Summary of Items Discussed in 1/2017 APSEC Discussion Forum on 13 January 2017

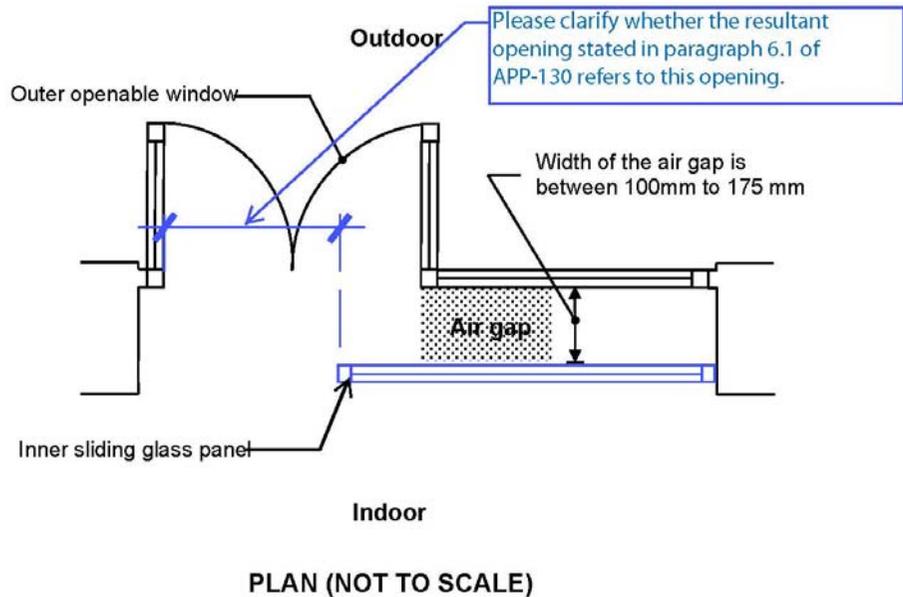
7.	<p><u>Openings through Beams for E/M services</u></p> <p>Under current practice, it is required to submit A&A plans for formation of openings through beams. As such alterations would usually be minor in</p>	BD advised that formation of openings for E/M services through beams might be complicated works involving structural strengthening in some

nature, it is suggested introducing provision under Class I Minor Works to streamline the process. If agreeable, AP/RSE could provide technical support to each individual minor works submission and maximum size of opening should be limited to 100 mm diameter.	cases. The scope of the proposed minor works item required further study.
